THE STATE OF SOUTH CAROLINA
In The Court of Appeals

Balfour Beatty Construction, LLC, Appellant,

AMENDED RECORD ON APPEAL - VOLUME 7 OF 20

Project: Hotel at Marion Square
Re: Request for Change Order # 052
MOD 1 Interior Glass Revisions R1

Description: Flush out gap above ballroom soffit and barrel vault ceiling per BBC

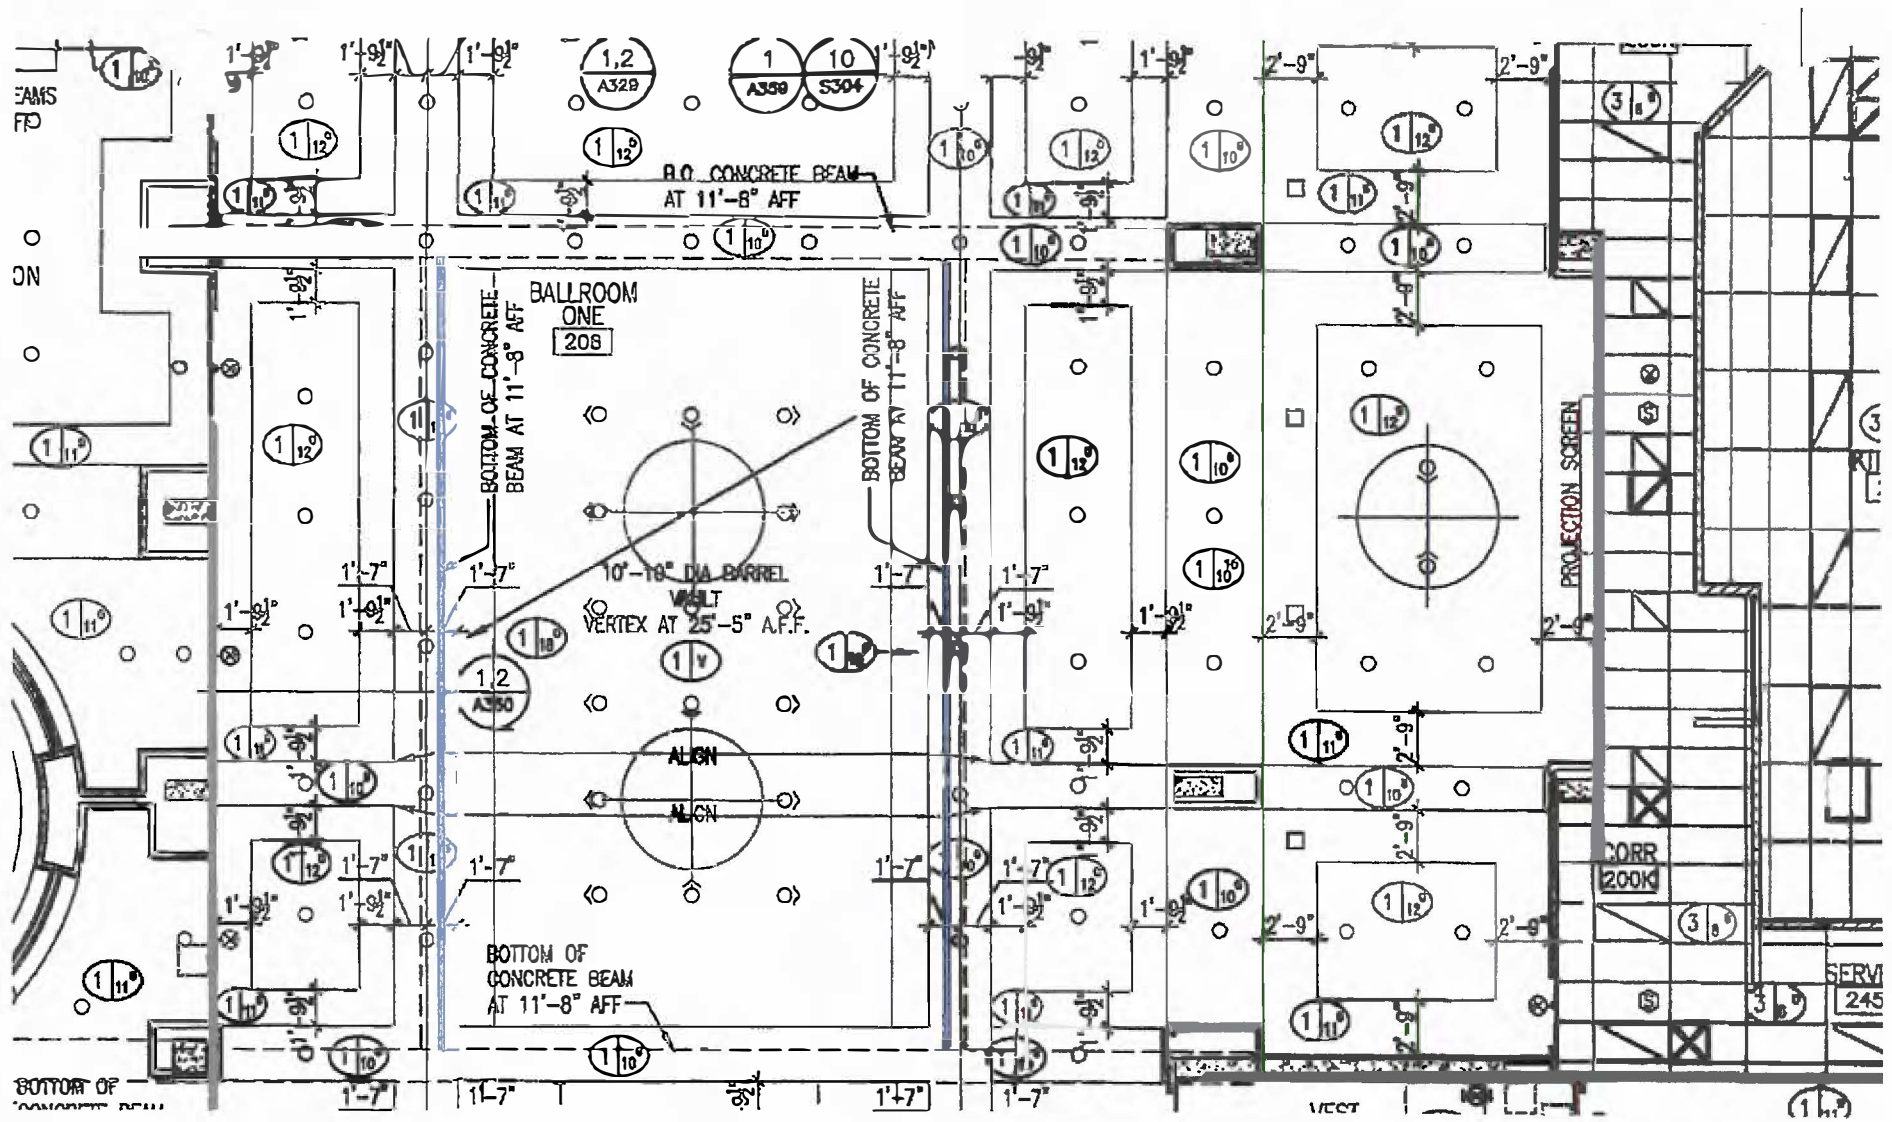
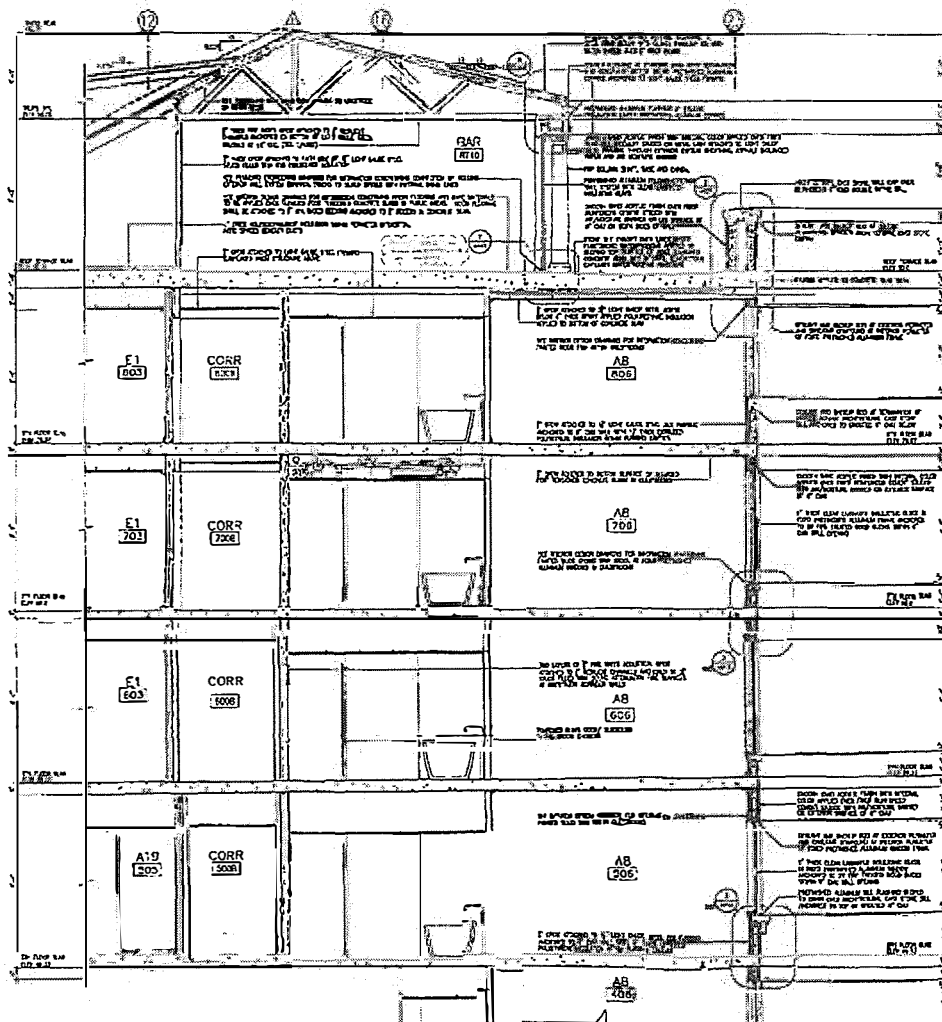
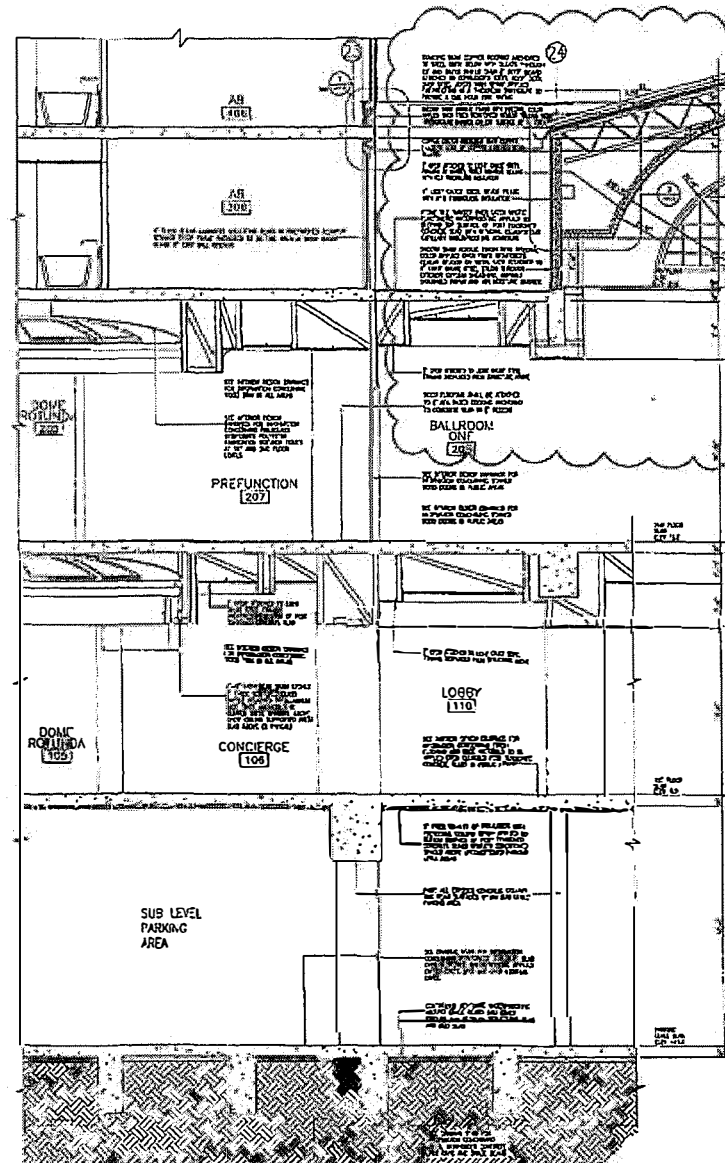
Notes: Furnish and install additional framing at ballroom soffits to flush out soffit where an inset is shown.
All work will be completed on overtime after 40 hour work week is complete. Please reference attached take off and marked up drawing.

GUEST ROOM WINDOW TRIM

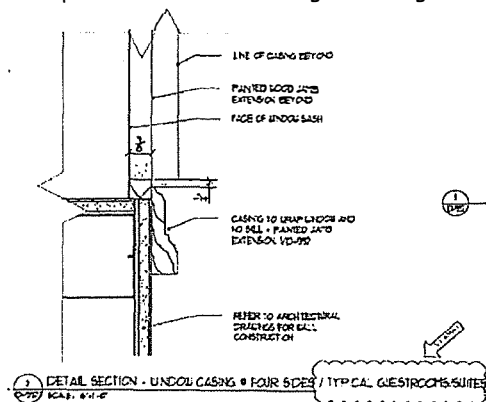
A total of (231) guest room windows will receive the following primed, paint grade trim per Detail 2 on Sheet ID-992.1:

SI #36 R1 clarified that the above detail is "Typical Guestrooms / Suites." SI #41 added the detail to the Guest Room Elevations on sheets ID-941 through ID-945.5.

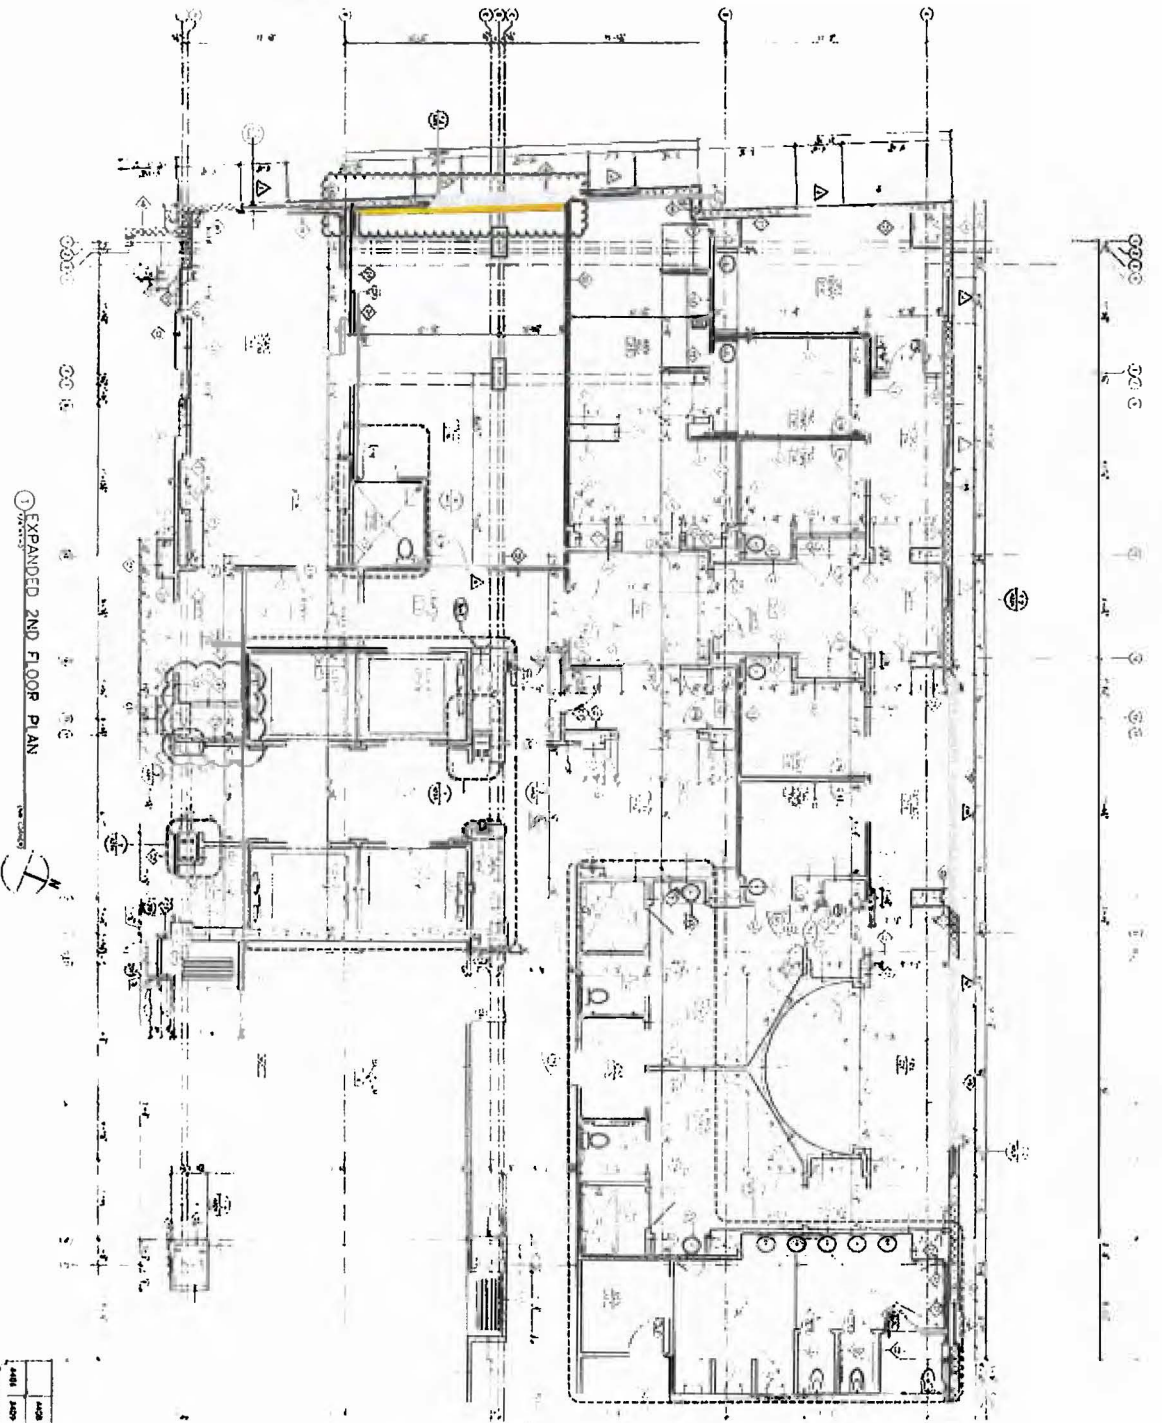
Notes: Add a 3-5/8" 20ga metal stud wall in front of the west wall of fitness that will NOT be insulated and it will be hung and finished for paint by others. This is for the LE light fixture.

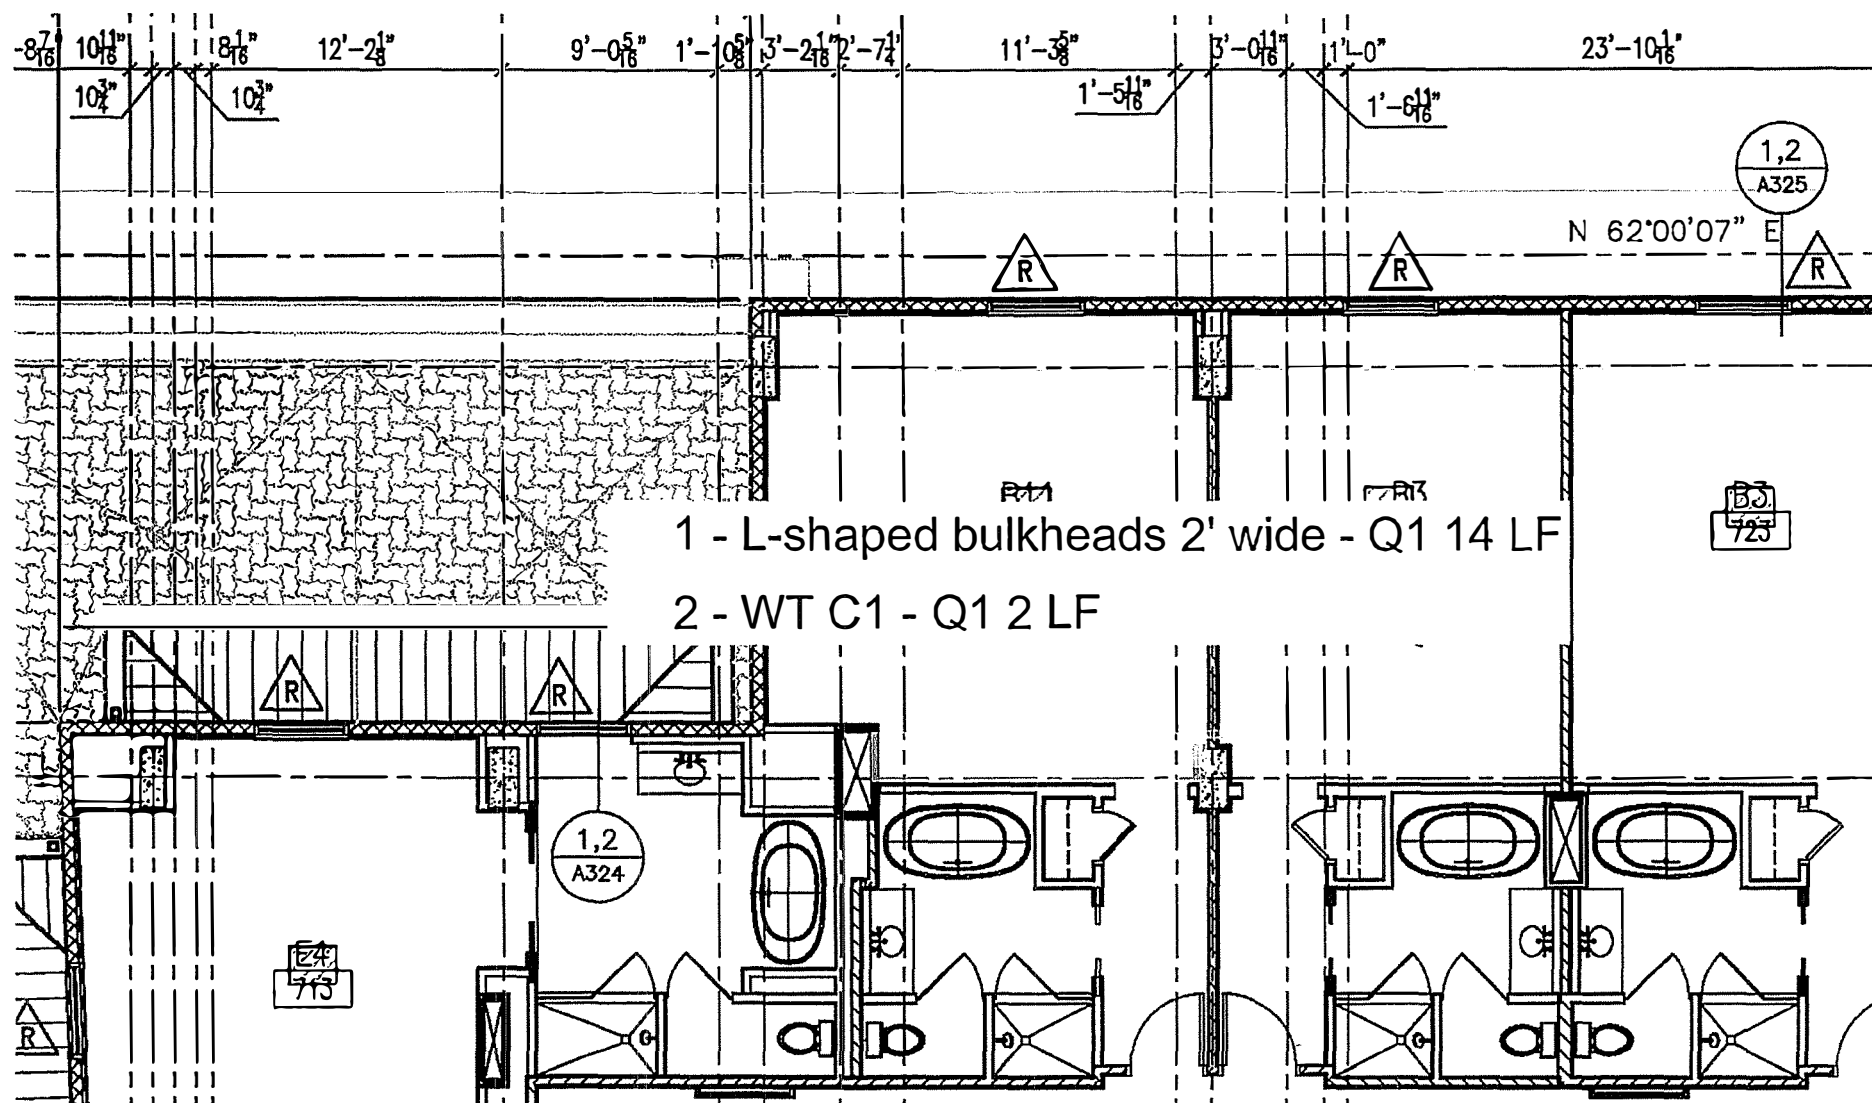
Notes: Furnish and install added soffits and column fur outs reference in RFI 1121 to cover up MEP per BIM.

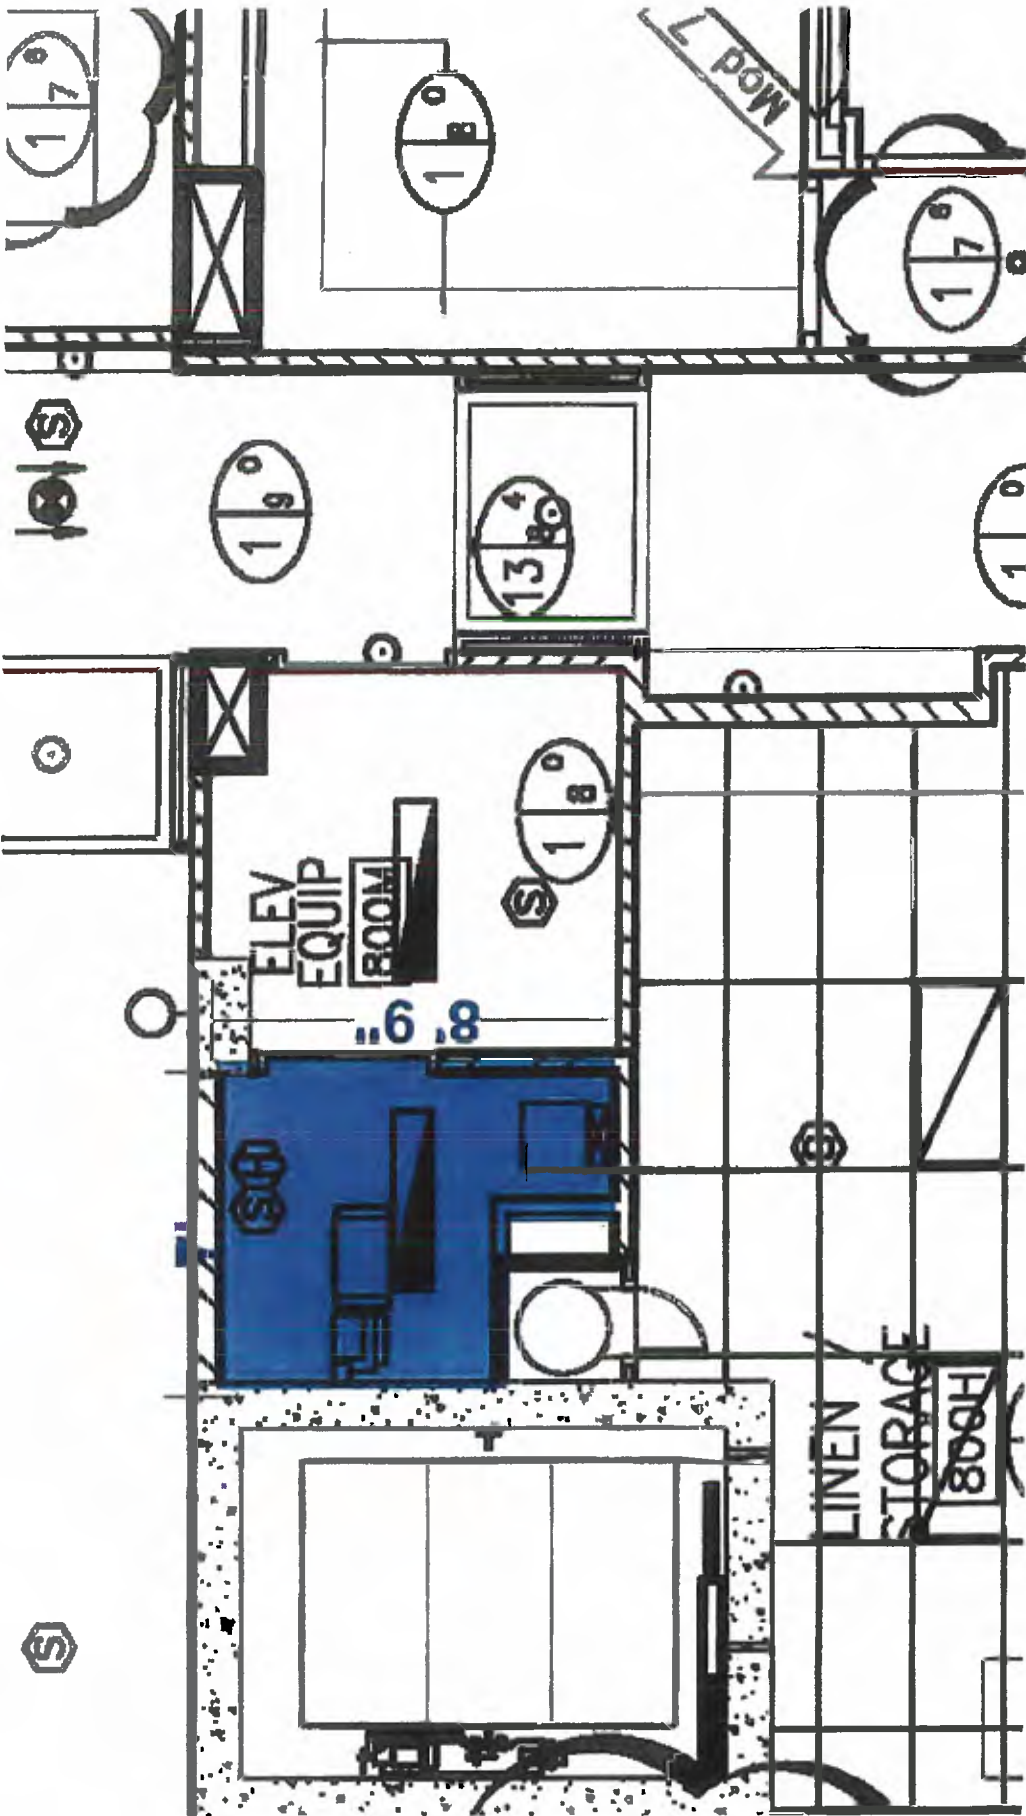
Install a 2 hour rated horizontal shaft wall ceiling per #NER-258 SYSTEM G on sheet A 382 to fully separate the pipes from the elevator equipment room per the response to RFI 0968.

Below the pan install a 2 hour rated horizontal shaftwall ceiling per #NER-258 SYSTEM G on sheet A 382 to fully separate the pipes from the elevator eq room.

Responder	Date	Response
Jennifer Faulkinberry	5/16/2017	Provide a fully welded minimum 20 gauge drain pan with 6" high ends. Locate a 3" drain at the end of the pan and route 3" drain to spill over LAV in Toilet 800J so if there is an issue with a pipe leak it will be observed by staff. Locate drain pan and drain as high as possible. Below the pan install a 2 hour rated horizontal shaftwall ceiling per #NER-258 SYSTEM G on sheet A 382 to fully separate the pipes from the elevator eq room. Jennifer G. Faulkinberry, AIA, NCARB Winford Lindsay Architect

RFI 0953 - BALCONY DOOR BASEBOARD

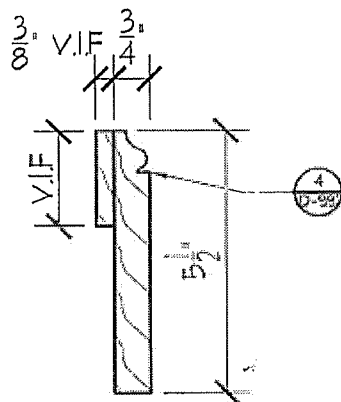
A total of (135) LFT of primed, paint grade base board (3/4" x 5-1/2") and fur-out (3/8" x 2") will be provided and installed underneath the (27) "Juliet Doors" on the 3rd Floor per RFI #0953, the attached take-off, and the detail below.
